HIDEOUT, UTAH PLANNING COMMISSION REGULAR MEETING

Staff Report for Elk Horn Springs – Concept Plan Review

Re: The Elk Horn Springs Concept Plan for the Salzman Property

Date: Prepared for the July 18, 2024 Planning Commission Meeting

The Elk Horn Springs Concept Plan (July 2024)

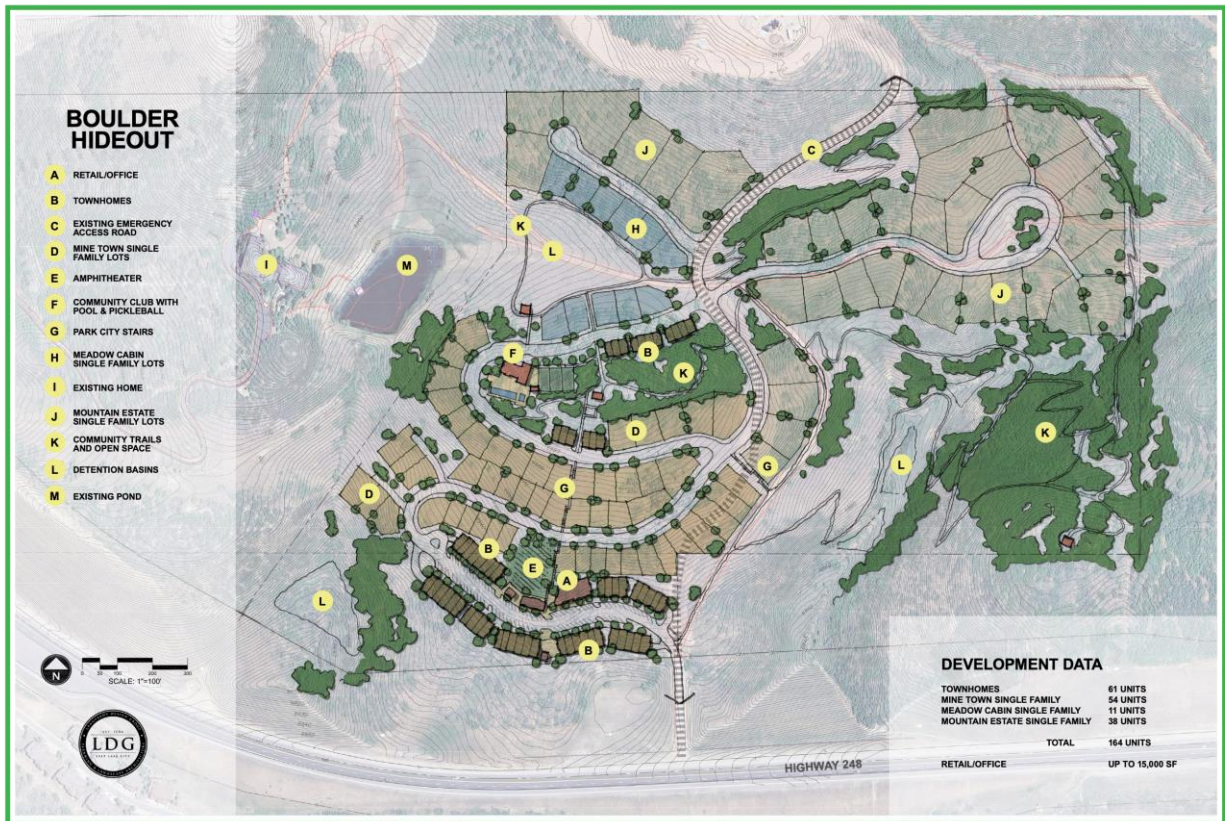
Density: The proposed density is +/-200% of what is currently allowed per the Mountain (M) residential zoning designation. Where +/-60 - 65 single-family units are permitted on one-acre lots, the Applicants propose +/-164 units. The proposed Concept Plan has clustered all development on the eastern portion of the site. The prior two Concept Plans (in 2022 and 2023) for this site proposed a density that was a 500%+, and 300%+ increase beyond existing allowances.

The proposed commercial area will provide the local/neighborhood commercial opportunities that are currently missing in the community and frequently requested by residents. The Applicant has not indicated the types of commercial tenants that would likely occupy these spaces, but special consideration should be given to uses such as a coffee shop, restaurants, a fitness/wellness studio, etc. neighborhood commercial amenities. A Master Development Agreement (MDA) will be necessary should this project proceed to a rezoning application. Staff recommends limiting all first floor uses to uses such as a coffee shop, restaurants, a fitness/wellness studio, etc. to prevent real estate offices and similar in those spaces, thus eliminating the neighborhood character/needs.

In addition, the Applicant and Planning Commission should consider increasing the amount of square feet for commercial space – perhaps up to 20,000 or 25,000 SF.

- The amphitheater could be changed to a green gathering, or park area, for the community. An amphitheater is currently proposed for Phase 4 of the Deer Springs development and Phase 4 or Phase 9 of Shoreline development. A more universal gathering space will likely prove more useful to the residents.
- The neighborhood commercial development could flank this park thus activating the space and drawing more residents and visitors alike to the unique setting.
- The parking for the Townhouse units on the main entry street is proposed to be under the units, allowing parking spaces along the street to be used for the commercial space.
- There may be an opportunity for workforce housing units above the proposed commercial space.

- The existing emergency access road from SR 248 to Golden Eagle bifurcates this property and the Applicant is proposing to generally use this as the main spine road for the development – in effect upgrading the road from its current road base conditions. There are some areas where the existing road is proposed to be moved outside of the easement that exists on the plat. The Applicant will need to coordinate this with Mustang Development (the entity who negotiated the easement) and the Town.

Access: There is only one ingress/egress proposed from SR 248 – approximately along the existing emergency access road leading up to Golden Eagle. A road, or stub, will also be required on the eastern property line to provide a connection to possible future development.

Space/Buffers: The proposed development has clustered areas with open space buffers providing park/trails proposed. Additional detail should be provided: type of trails, surface treatment, etc.

Sensitive Lands: Per the Town’s updated Zoning Code, areas with greater than 30% slopes Slopes, must be preserved – development activity including buildings and roads and vegetation: must be moved to areas with less than 30% slopes. Major drainage ways - valleys and ravines - must also be protected from development to the greatest extent possible. If this project moves forward, a grading plan with cut and fill clearly indicated will be required for review.

Infrastructure: Issues regarding water rights and availability must be addressed. Additionally, it is assumed all road infrastructure will be financed by the developer. Will the roads, upon completion, be maintained by an HOA? A phasing plan should ultimately be presented. Is a traffic signal proposed at the entry road and SR248?
